R01FF

July 30, 2001

Blue Bird Body Company has determined that a defect which relates to motor vehicle safety exists in certain Blue Bird TC/2000 rear engine buses, Commercial Series rear engine buses and Q-Bus rear engine buses manufactured from 1996 model year through May of 2001 model year. Blue Bird is conducting a recall to correct this defect.

RECALL R01FF
SECTION I

Battery Cable Routing and Reinstallation.

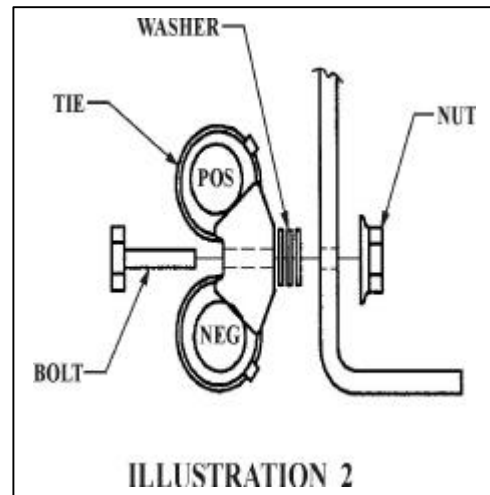
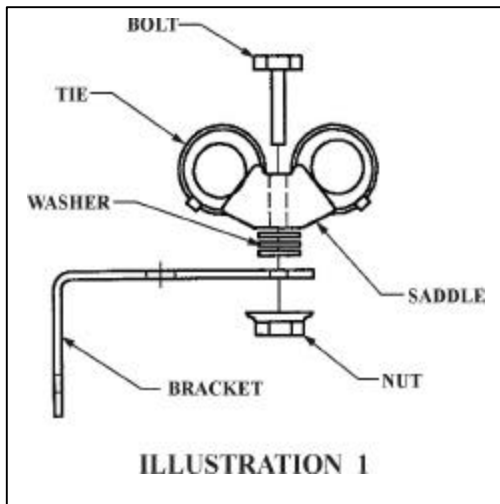
- I. Having noted the routing of the cables before removal, install the 2-way saddle mounts to support cabling along the frame rail and crossmember. The use of brackets to support the saddle mounts may be necessary providing the required clearance to other cables or lines. The heavy-duty mount can be used for single electrical cable requirements. Refer to the illustrations for assembling the saddle mounts.

1. The battery cables must be routed independent of all other cables, lines, or hoses.
2. Cable mounts should be at a maximum interval of 24 inches and secured as close as it is permitted to all cable bends.

FIGURE 1

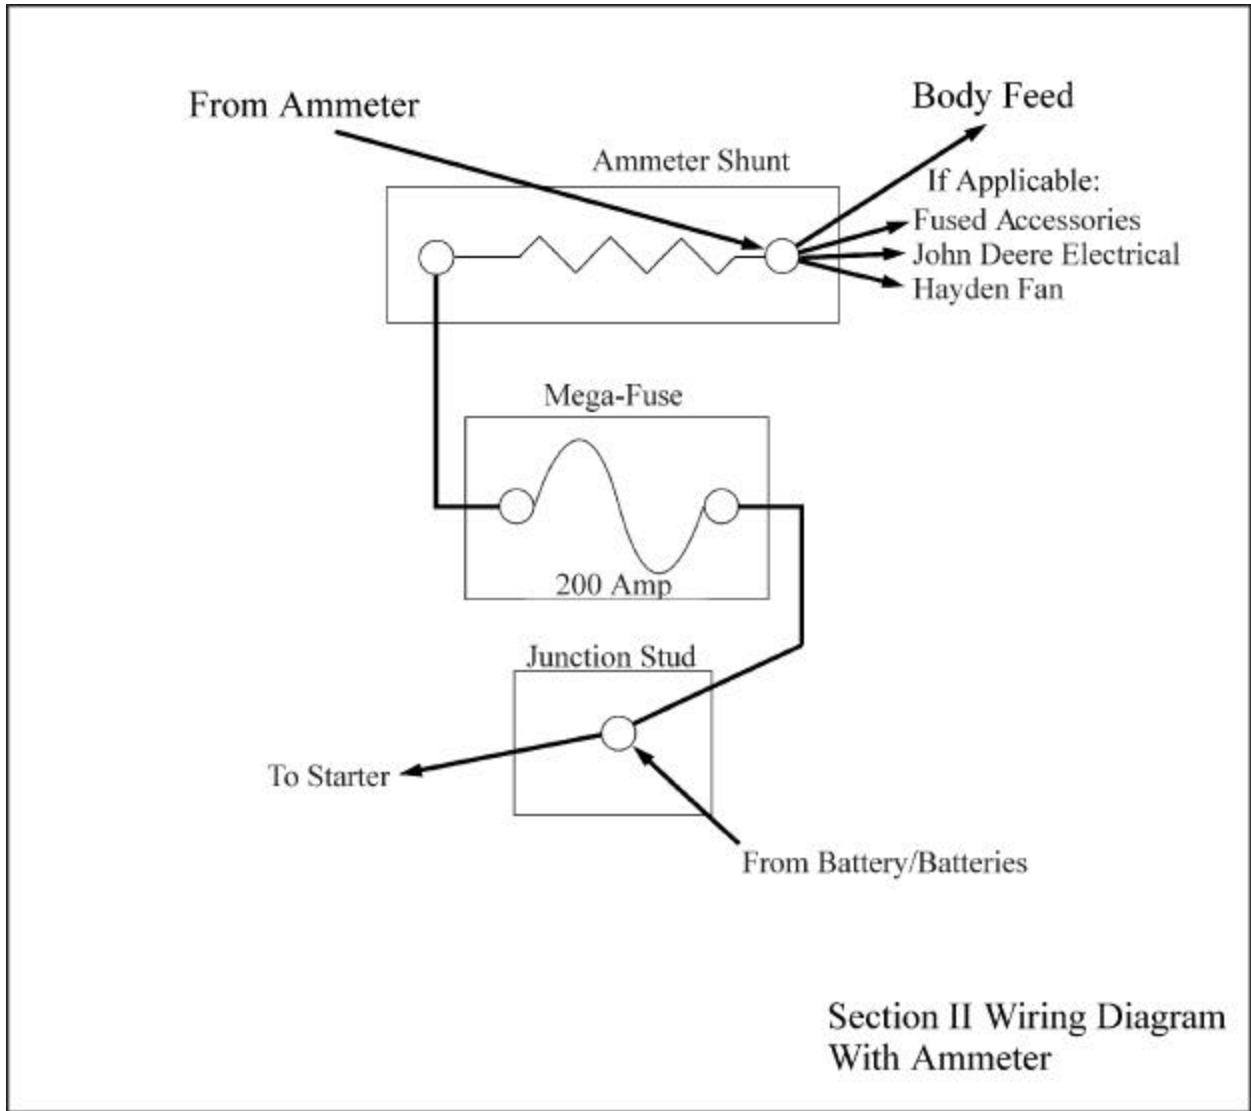
- D. Refer to Figure 1 (for units with ammeter) on page 5 and Figure 2 (for units without ammeter) on page 6 for the proper cable and wiring connections. Install the Mega-fuse and cable assemblies between circuits as required. Position the Mega-fuse to prevent interference to other wiring components.

Instructions for Installing 200 Ampere Mega-fuse Circuit Protection for Alternator and Body Hot Cables.

- E. Secure all threaded electrical connections. Torque 5/16 inch hex nuts to 10 ft./lbs. and 3/8 inch hex nuts to 20 ft./lbs. Coat cable ends and terminal posts with electrical grade silicone RTV or Glyptal enamel.
